Product Change Notice (PCN)

PCN Number: **PCN-0370535R-01**

Product(s) Affected: **CMT-0525-75-SMT-TR**

Previous Orientation	Current Orientation

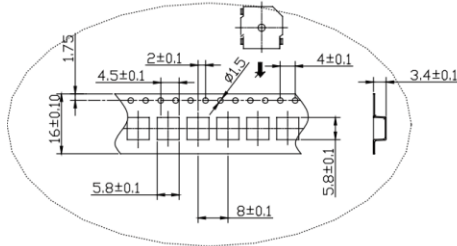
Reason(s) for Change: **Upgraded reel machine.**

Description of Change: **Buzzer shifted 90 degrees in the tape. See drawing below for tape update.**
